HORSHAM DISTRICT COUNCIL CONSULTATION

TO:	Horsham District Council – Planning Dept
LOCATION:	Woodfords Shipley Road Southwater
DESCRIPTION:	Reserved matters application for the erection of up to 73no. dwellings, open space and child play provision, residential parking facilities and associated infrastructure, including access arrangements following outline application DC/21/2180, relating to layout, scale, appearance and landscaping.
REFERENCE:	DC/25/1658
RECOMMENDATION:	Advice/Modification
SUMMARY OF COMMENTS & RECOMMENDATION: The proposed layout is relatively favourable towards arboricultural constraints at the site. Significant boundary trees and hedgerow features are largely retained, and tree loss is for the most part limited to low-quality, dead, or diseased specimens or minor hedgerow sections required for access. Some incursions into RPAs occur, and have been technically justified, and mitigated through appropriate no-dig construction and arboricultural supervision, although some amendments to the route of the drainage infrastructure in some areas to avoid RPA conflicts. The proximity of a small number of dwellings to mature boundary oaks may give rise to some future resid

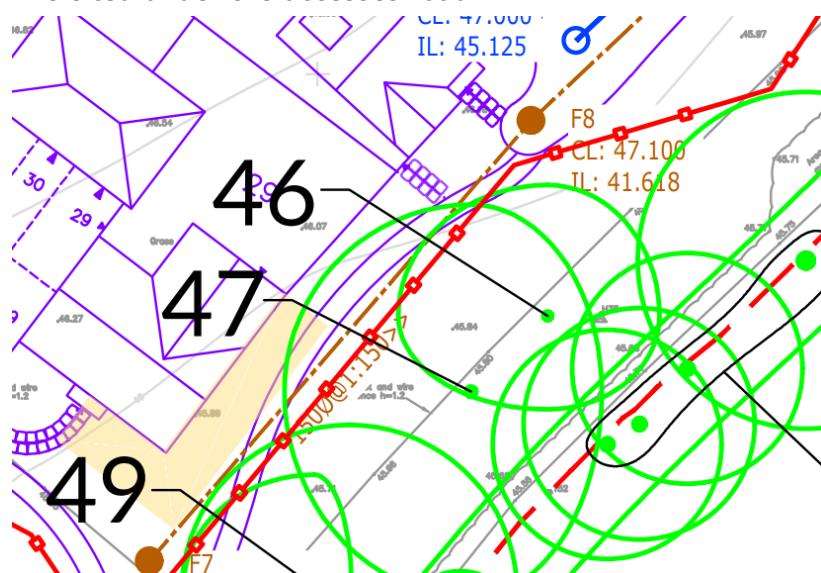
TPO trees in northeast corner – Drainage infrastructure sited in southern section of RPAs, given the protected status of the affected trees this should be moved and any drainage infrastructure should be located outside of RPAs, and the Pumping Station should also be moved at least 2m to the south, to allow for an appropriate amount of separation from the RPAs in the area, not only to protect the RPAs during the build process, but also form likely post development impacts. Whereby, new infrastructure often requires ongoing maintenance and occasional intrusive repair, posing additional long-term risks to the affected protected trees and their RPAs, should any underground services need to be re-opened to allow for future repairs to the pipework post development.

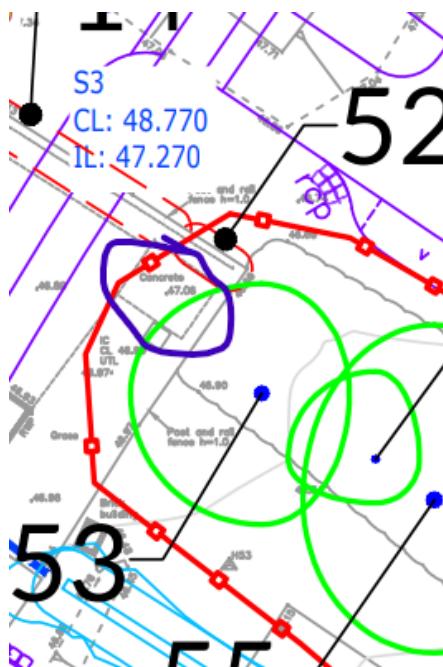
T47 - It is apparent that drainage infrastructure sited with the RPA of T47, as with the section of drainage infrastructure in the northeast corner this should be removed from the RPA of the affected tree. Also there is no reference to no no-dig build methods where the RPA of T47 is sited under the accesses road.
